Re: S.96 (1A) Modification to modify Development Application 6114 for the construction of mountain bike trails – Stage 1A, High Noon and Dream Run Ski Run Deviations, Thredbo Alpine Resort

ATTACHMENT A – S.96 MODIFICATION PLANNING REPORT

RE: S.96 modification to Stage 1 All Mountain Trail DA – Thredbo Ski Resort

Figure 1: Proposed realignment to Thredbo All Mountain Trail - High Noon/Dream Run

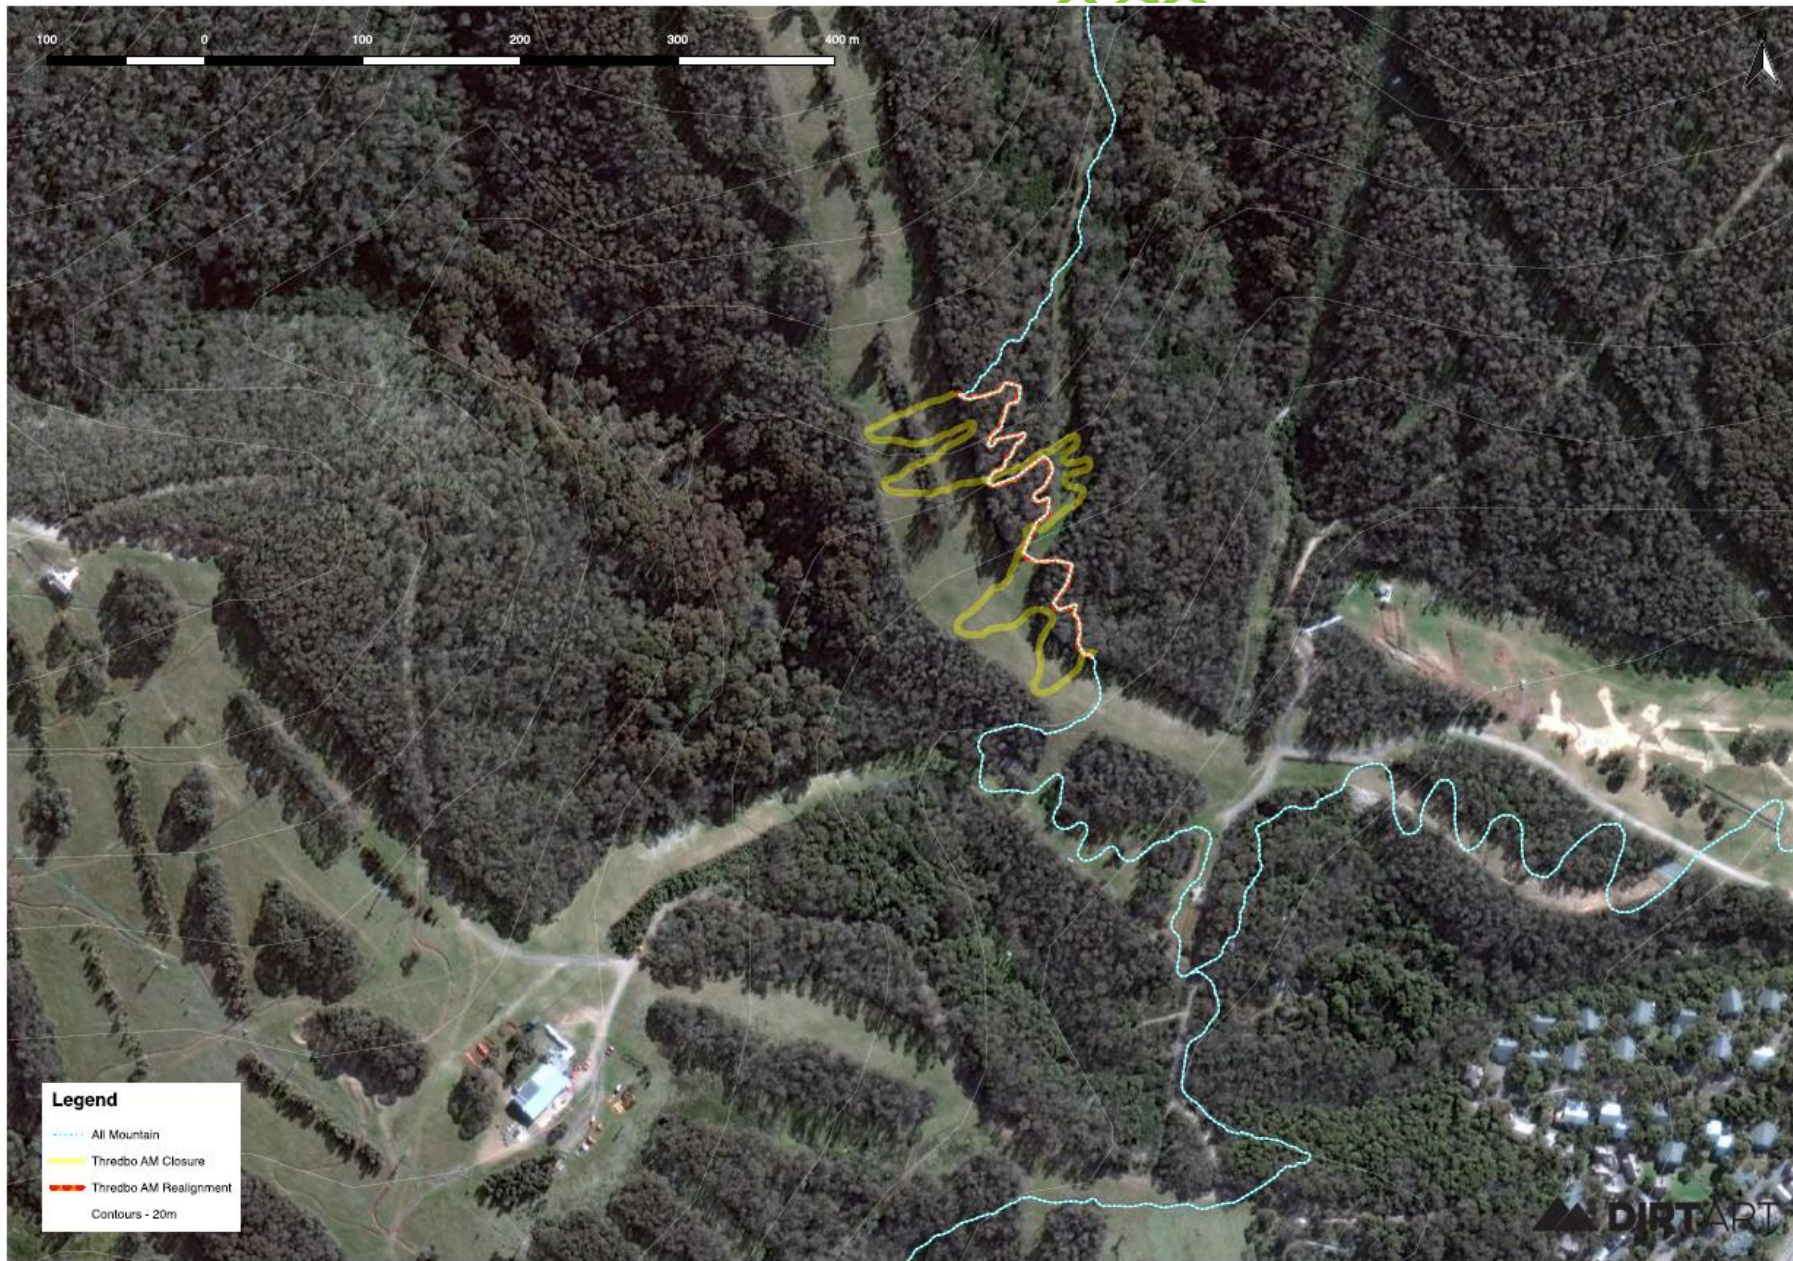
High Noon/Dream Run – Described as Thredbo AM Realignment in **Figure 1**, the realignment substantially reduces the extent to which the All Mountain Trail traverses the High Noon and Dream Run ski runs. Instead the proposed realigned trail will traverse the Subalpine Woodland adjoining these runs as identified in **Figure 1** and **Photo 1** and **Photo 2** below. The proposed realignment is 439 m in length, approximately 390 m of which traverses Subalpine Woodland. The proposed realignment will remove the hazard the sections of trail on the ski runs pose to skiers and mountain operations. As the sections to be realigned are on relatively steep ski slopes, the berms are quite high, and are a hazard to skiers and skidoos, particularly in low snow conditions.

Figure 2: Proposed realignment to Thredbo All Mountain Trail - Merritts Nature Trail

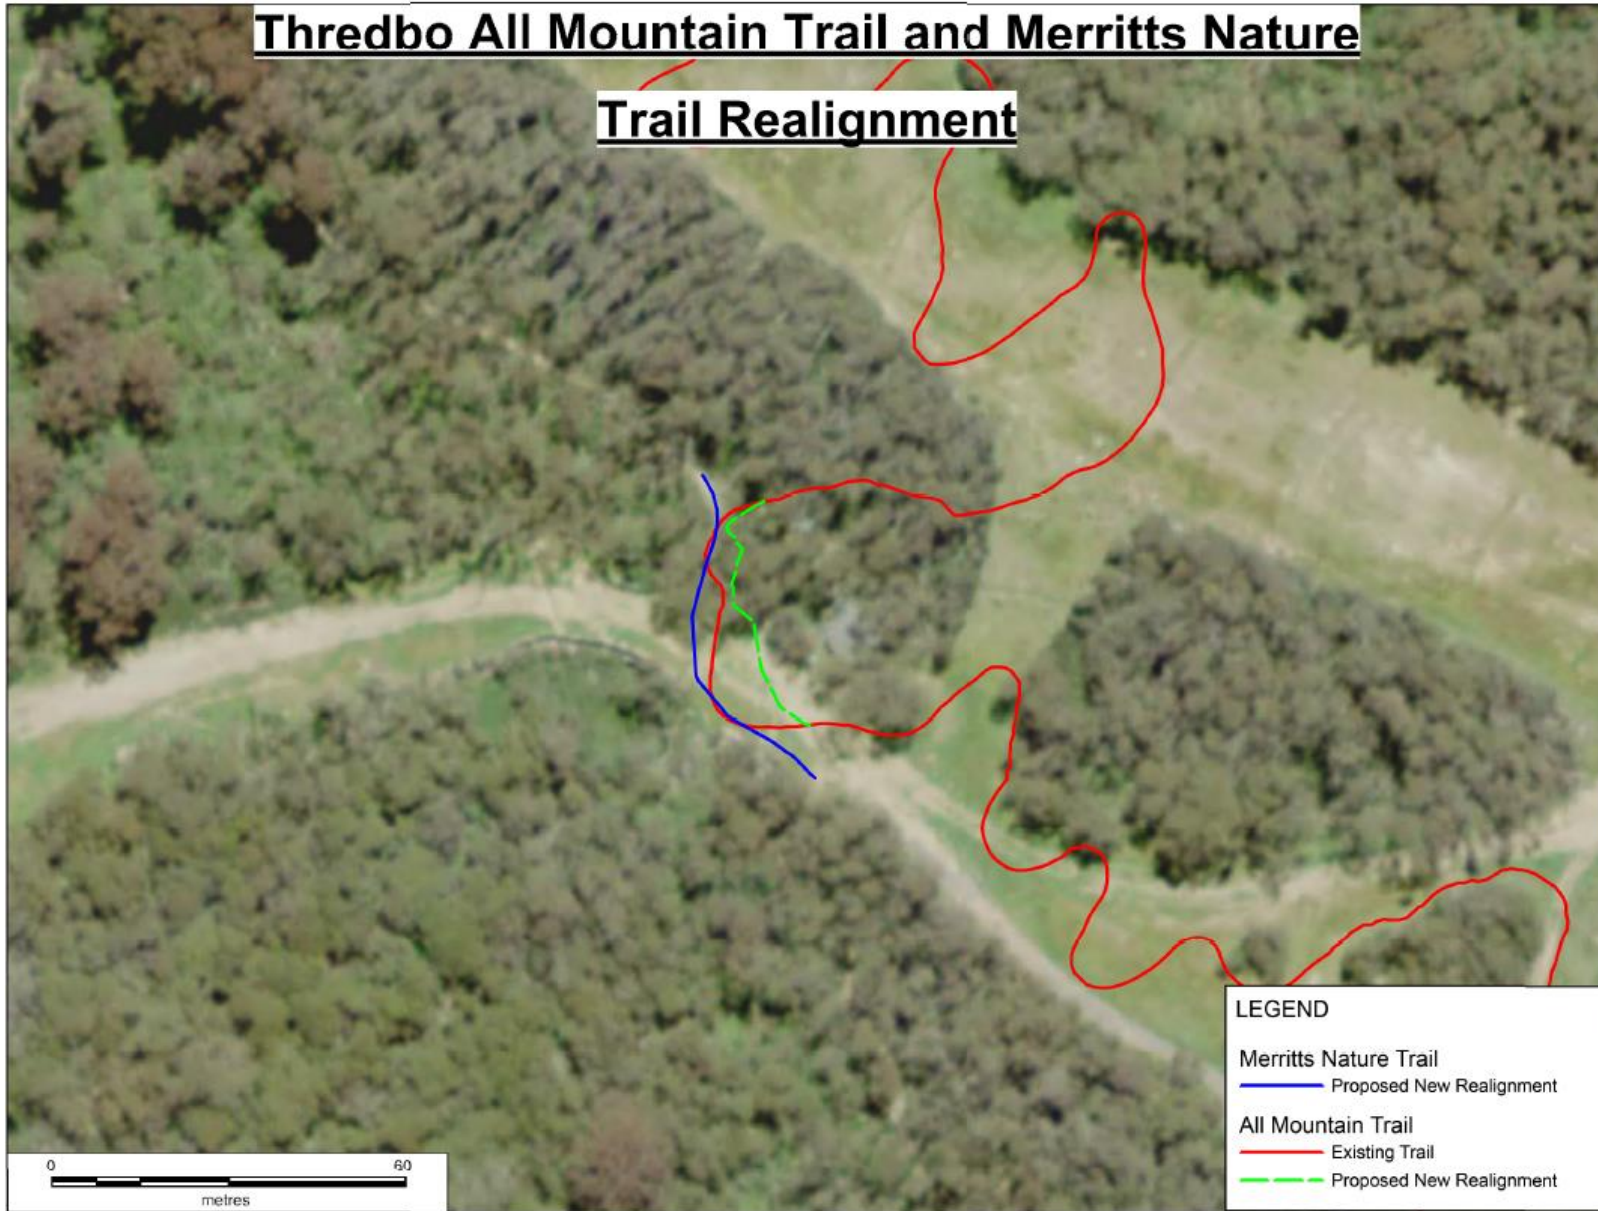
Merritts Nature Trail – Described as Proposed New Realignment in **Figure 2**, the realignment removes an approximately 10 m section of trail that is shared by the Thredbo All Mountain Trail and the Merritts Nature Trail, adjacent to the Sundowner ski run. The shared section of trail includes a corner with poor visibility, as shown in **Photo 3**, and poses a real danger of collisions between walkers and mountain bikers. The proposed realigned trail will traverse approximately 15 m of Subalpine Woodland and will separate walkers and mountain bikers.
